Safety Evaluation Report for an Early Site Permit (ESP) at the Exelon Generation Company, LLC (EGC) ESP Site

U.S. Nuclear Regulatory Commission
Office of Nuclear Reactor Regulation
Washington, DC 20555-0001

May 2006

Figure 2.4-3 Proposed locations of ESP facility UHS intake and discharge

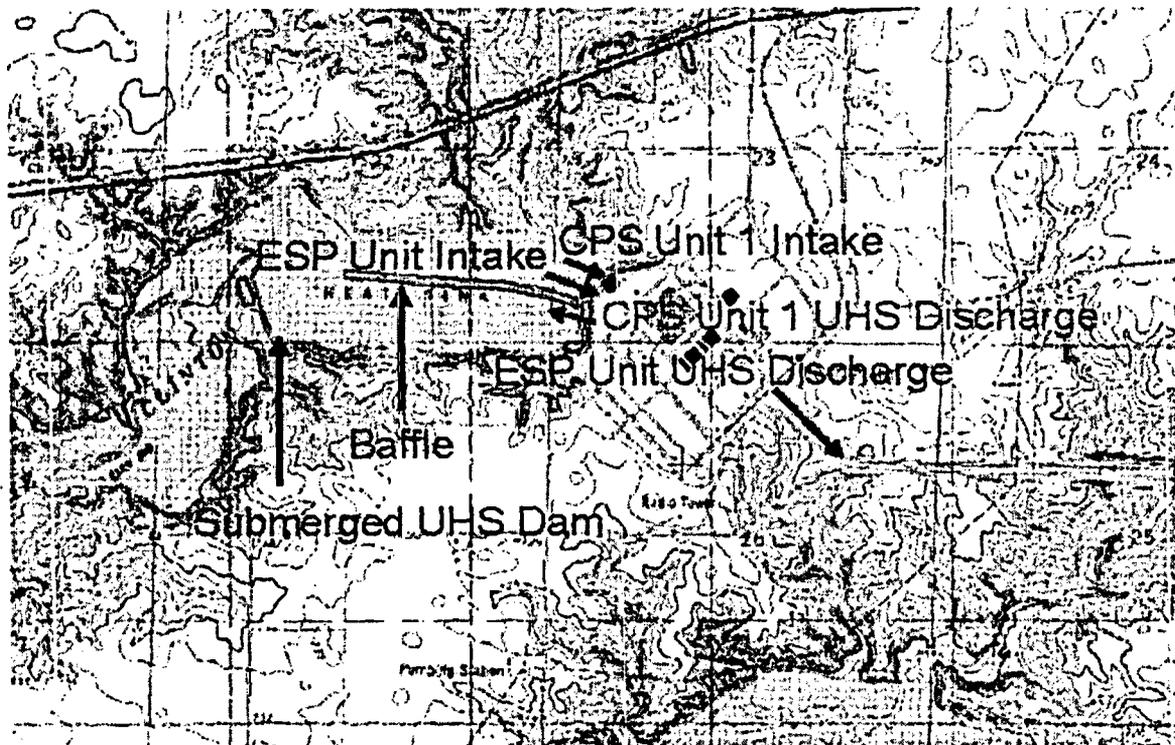
In Request for Additional Information (RAI) 2.4.1-1, the staff asked the applicant to provide survey coordinates (including elevations) for the bounding areas of all ESP facility safety-related structures, including intake tunnels and piping corridors. The staff also requested that the applicant provide coordinates of existing aquifers in bounding areas, particularly perched aquifers. In response to RAI 2.4.1-1, the applicant provided an updated figure to replace Figure 1.2-4 in Chapter 1 of the site safety analysis report (SSAR). The applicant stated that this figure shows the approximate location of safety-related structures, along with a grid system overlaid on the figure.

Figure 2.4-10 Dawson Lake and Dam located approximately 17.1 miles north-northeast of the ESP site. Dawson Lake is located on the North Fork of Salt Creek.

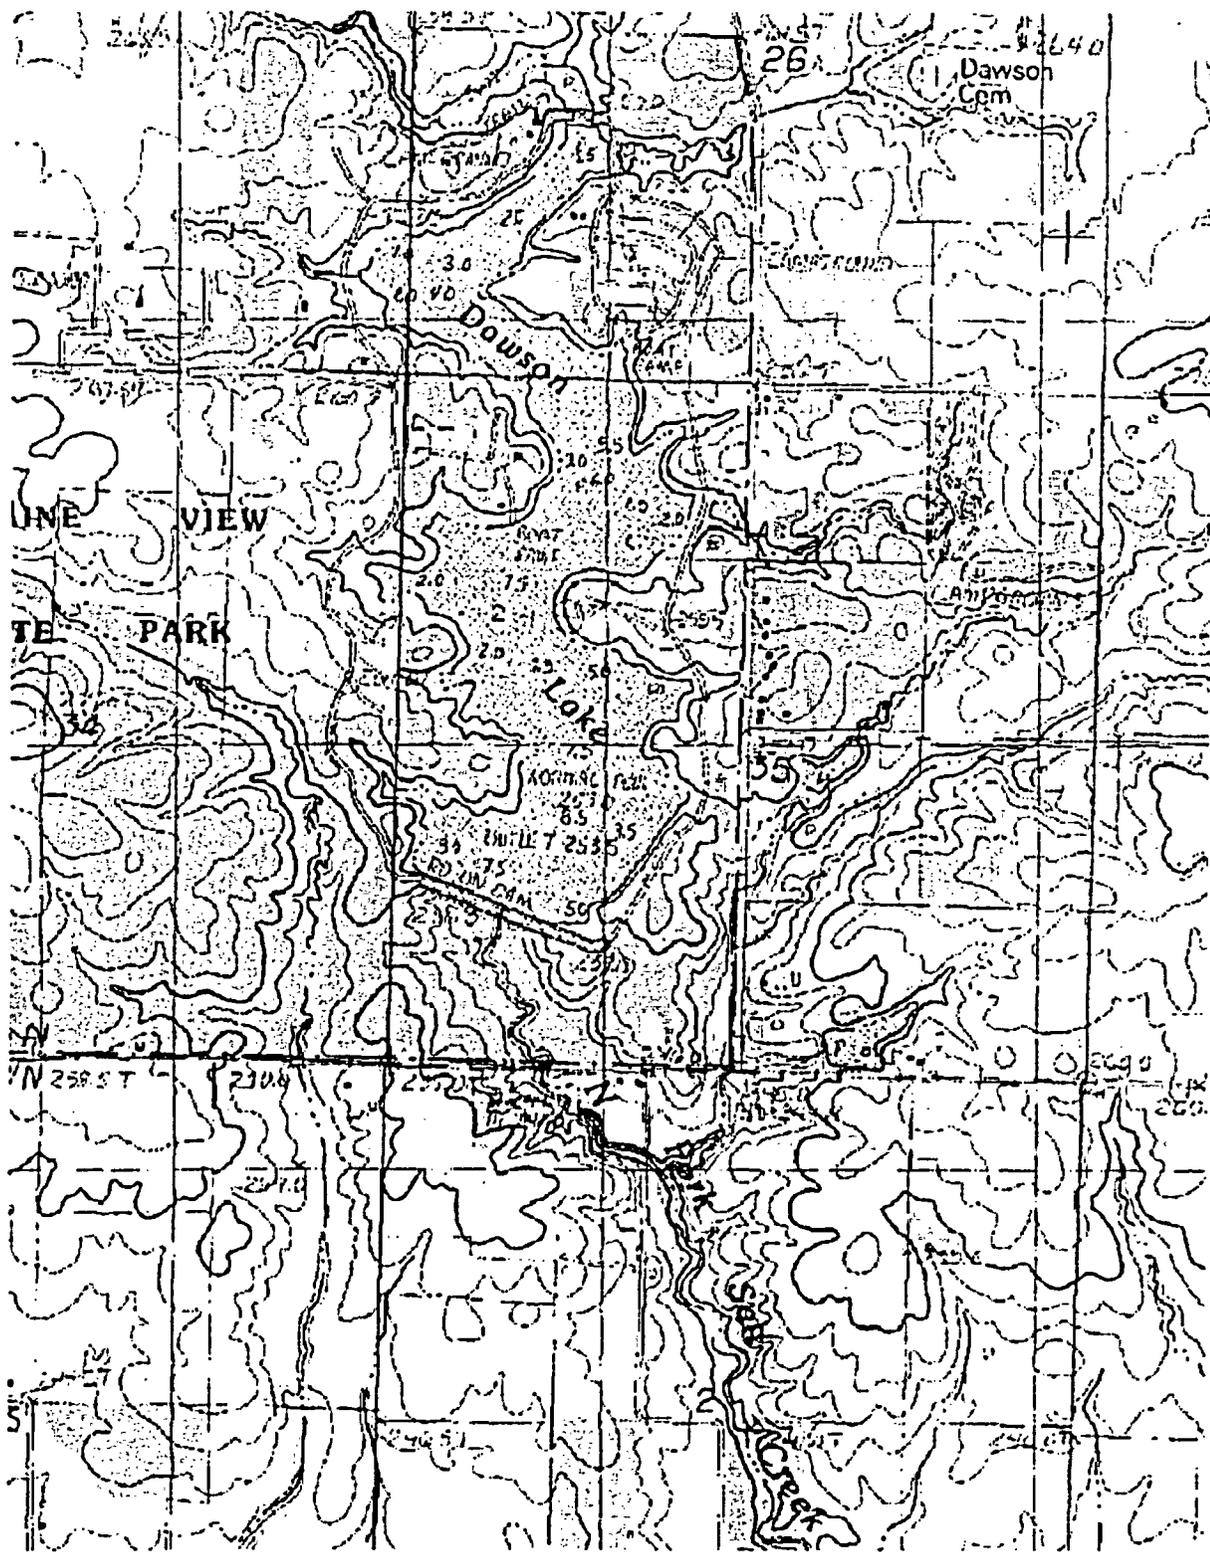
The staff determined that the maximum combined storage capacity of the two reservoirs upstream of Clinton Lake is 4446 ac-ft. The original capacity of Clinton Lake at normal water surface elevation of 690 ft MSL, as determined by the staff using the stage-storage relationship for Clinton Lake given in CPS USAR Figure 2.4-14, is 74,200 ac-ft. The maximum combined storage capacities of the two reservoirs upstream of Clinton Lake is about 6 percent of the normal storage capacity of Clinton Lake. The staff determined, using the same stage-storage relationship for Clinton Lake, that an increase in storage by 4446 ac-ft, with an initial water surface elevation in Clinton Lake of 690 ft MSL, would result in an increase in water surface elevation of 3.1 ft. This estimate is very conservative, since it ignores water discharged over the service spillway when the water surface elevation in Clinton Lake exceeds its crest elevation of 690 ft MSL. Discharge over the service spillway reduces the water surface elevation in Clinton Lake, and the final increase in water surface elevation resulting from a breach of the two upstream dams is likely to be less than 3.1 ft.

The staff's estimate of maximum water surface elevation in Clinton Lake because of PMF, wind setup, and wave runup, as discussed in Section 2.4.3 of this SER, is 716.5 ft MSL. The staff plans to include 716.5 ft MSL as a site characteristic in any ESP that might be issued for this application. Even if the maximum water surface elevation in Clinton Lake were to be augmented by 3.1 ft because of a breach of the two upstream dams, leading to a water surface elevation of 719.6 ft MSL in Clinton Lake, the ESP site, located at 735 ft MSL, would be safe from flooding. Therefore, the staff determined that the applicant's response to RAI 2.4.1-3 is satisfactory.

Figure 2.4-14 AFDD during 1977-78 as calculated by Engineering Research and Development Center, Hanover, New Hampshire.

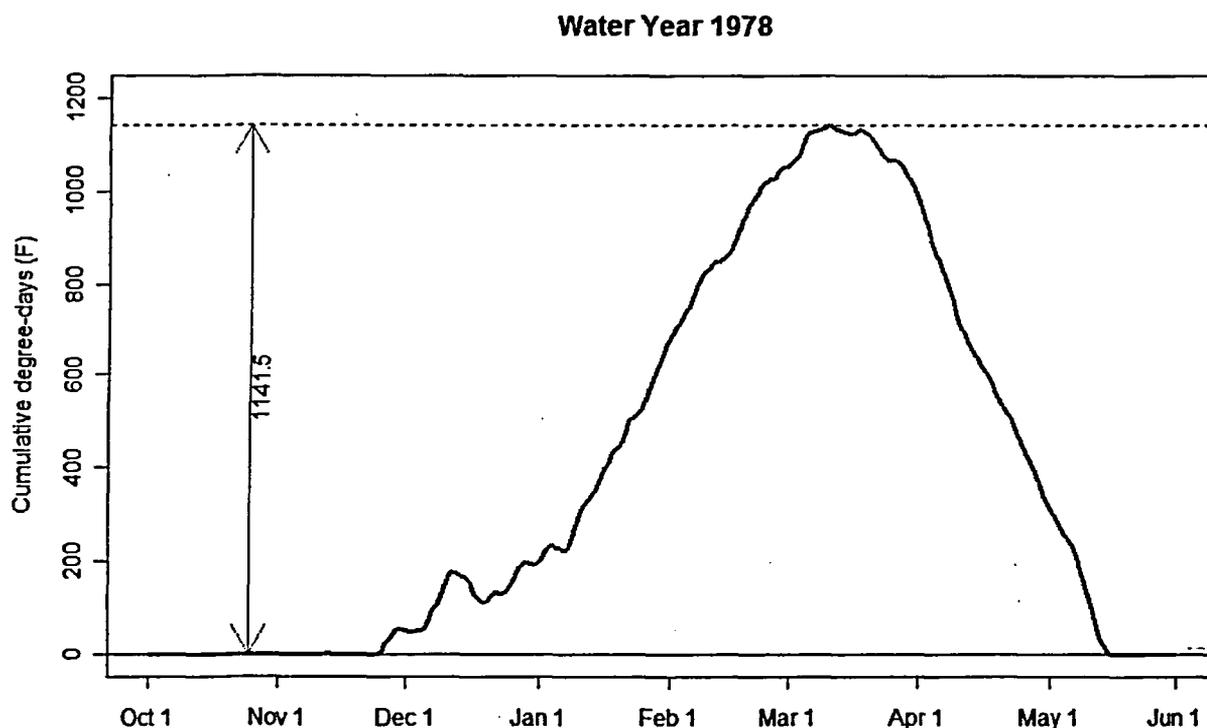
60 percent in December, 21 percent in January, four percent in February, and one percent in March. Fifteen percent of “zero AFDD” dates preceded December 1. The staff determined that winter of water year 1978 (calendar-years 1977-1978) was the coldest on record with a maximum AFDD of 1141.5 °F (Figure 2.4-14 below). The “zero AFDD” day for this year was November 25, 1977. The maximum AFDD occurred on March 10, 1978. The staff revised their estimate of maximum ice thickness in Clinton Lake to 27.0 in as shown below.

In a letter dated December 21, 2005, the applicant revised its maximum ice thickness estimate to 27.0 in. The applicant also revised its earlier response to Open Item 2.4-11 in this letter and revised its estimate of reduction in the storage capacity within the submerged UHS pond in presence of surface ice. The applicant stated that the reduction of storage capacity in the submerged UHS pond due to an ice sheet 27.0 in. in thickness will be approximately 326 ac-ft. Based on applicant's revised response to Open Item 2.4-11, the staff determined that applicant's revised ice thickness is identical to the staff's independent estimate. Therefore, the staff considers Open Item 2.4-11 resolved.

Figure 2.5.2-7 Four mean seismic hazard curves (1 Hz, 2.5 Hz, 5 Hz, and 10 Hz) for EGC ESP site plotted on a log-log scale. Dashed lines indicate annual probability of exceedance intervals of 10^{-4} per year and 10^{-5} per year.

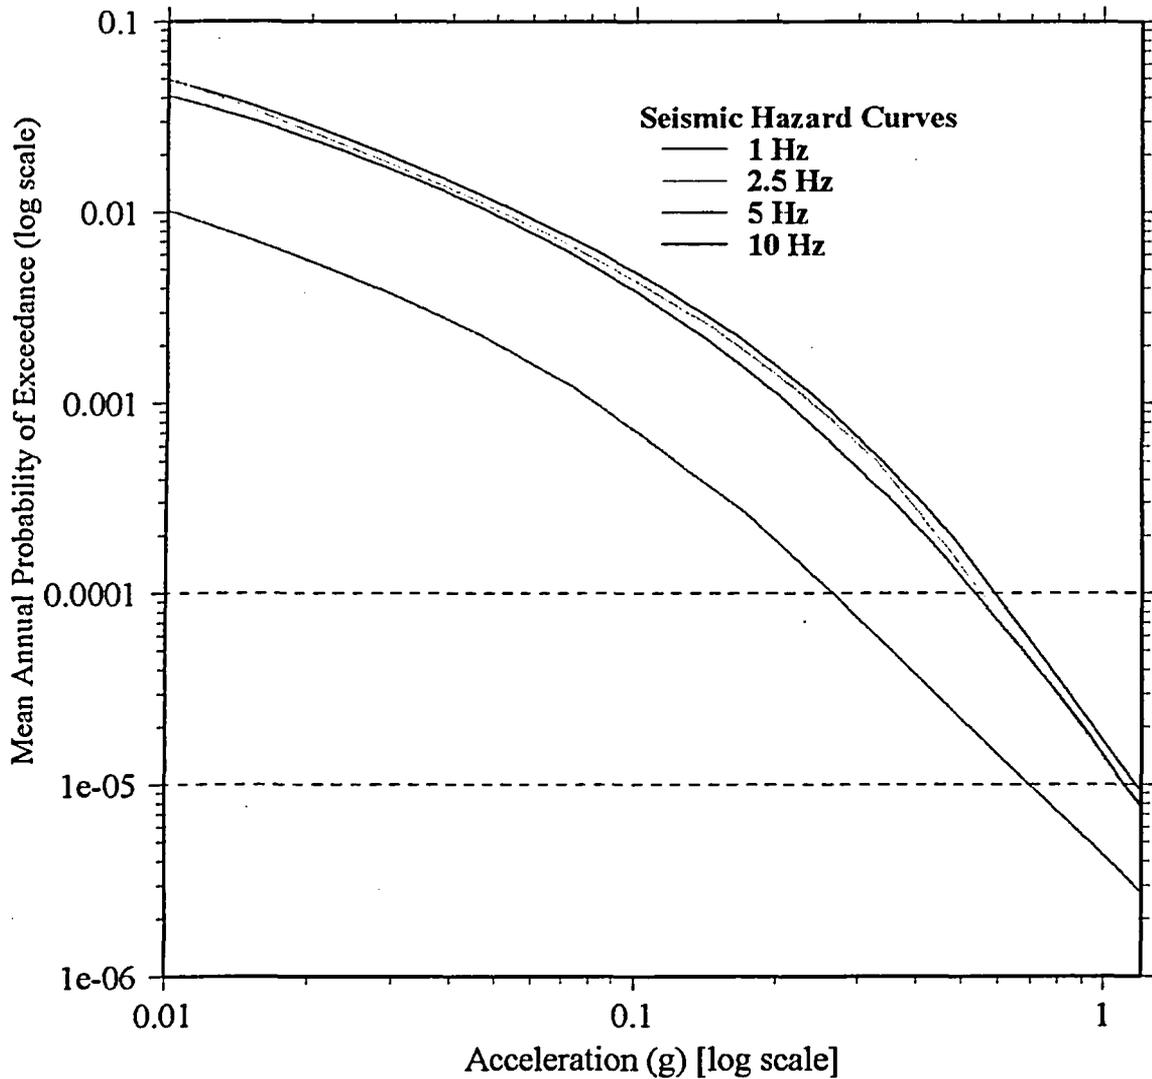
Linear Hazard Equation. In Open Item 2.5.2-5(a), the staff asked the applicant to justify the assumption of a linear hazard curve in logarithmic space (see Equation 2.5.2-13 and Figure 2.5.2-7) and the appropriateness of solely using the 10^{-4} to 10^{-5} interval to determine the amplitude ratio A_R and, as such, the DF. In response, the applicant stated the following:

Since the seismic hazard curves have a slight downward curvature, as illustrated in Figure 2.5.2-7, assuming a linear fit results in slightly higher exceedance values and, as a result, slightly higher SSE values, as illustrated above in Table 2.5.2-4. Therefore, the staff concludes that the applicant’s use of the approximate power law hazard curve is slightly conservative and therefore acceptable.

Figure 2.5.2-14 Comparison of exact and approximate *DF*. Exact *DF* varies with both A_R and β , while approximate *DF* depends only on A_R .

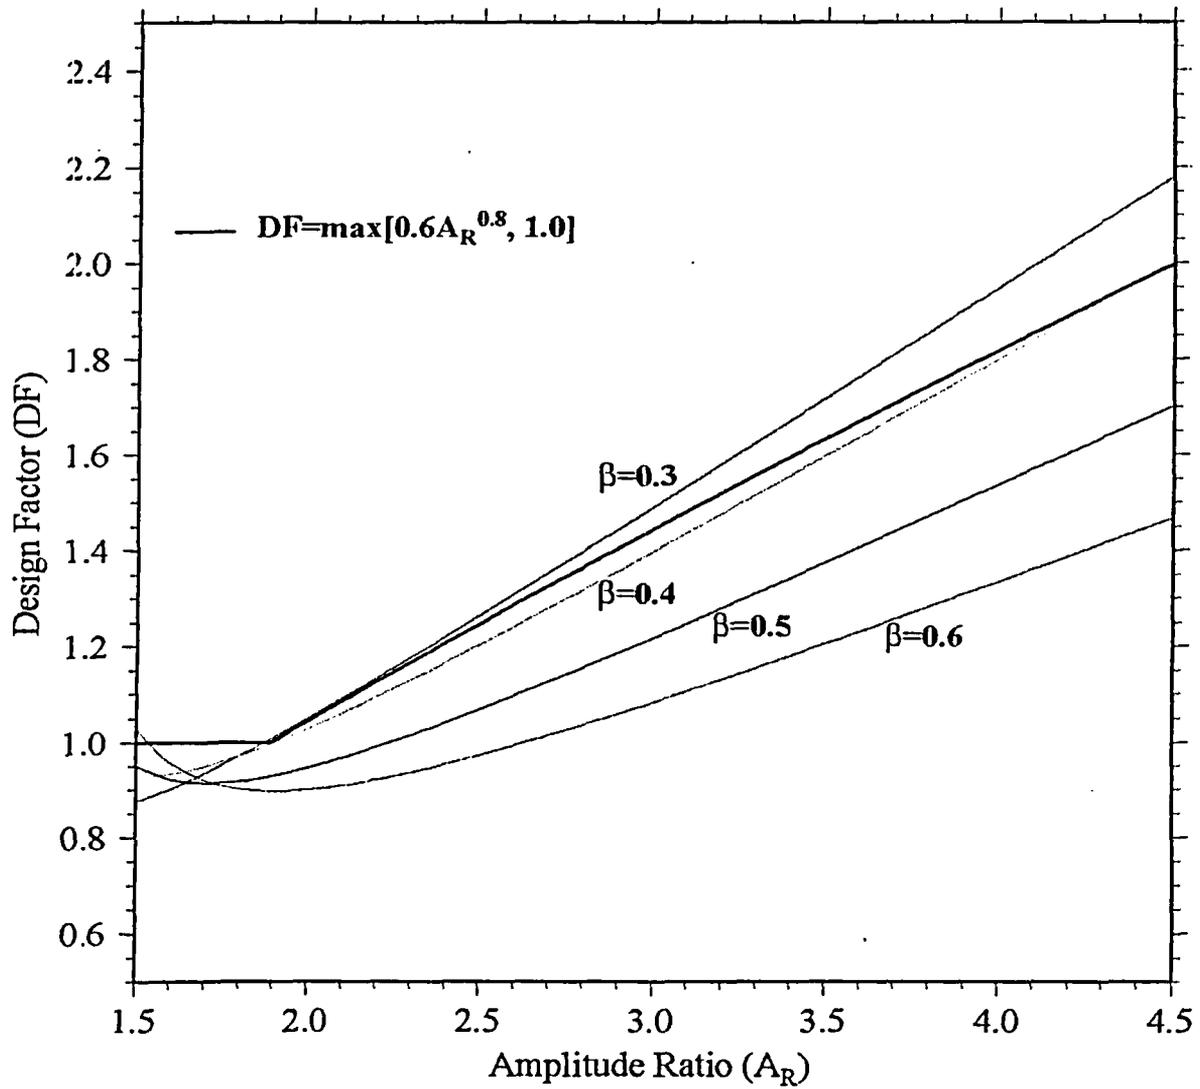
As shown previously in Figure 2.5.2-14 in Section 2.5.2.1.6.1, the DF recommended in ASCE/SEI 43-05 (Equation 2.5.2-1) is slightly unconservative for $\beta=0.3$ and conservative for larger β of 0.4 to 0.6. To evaluate the significance of the range of β values on the DF, the staff determined the unacceptable performance frequency values (P_{FT}) for the performance-based SSE values for four natural frequency values 1, 2.5, 5, and 10 Hz. The applicant determined the four performance-based SSE values shown below in Table 2.5.2-5 using the performance-based approach as described in ASCE/SEI 43-05, which assumes a β value of 0.4 and a target performance goal of $1 \times 10^{-5}/\text{yr}$. The staff used the four hazard curves provided by the applicant to determine P_{FT} via direct integration of the risk integral (Equation 2.5.2-9) for β ranging from 0.3 to 0.6. As shown below in Table 2.5.2-5, the P_{FT} values for $\beta=0.3$ are only slightly larger than the target value of $1 \times 10^{-5}/\text{yr}$.
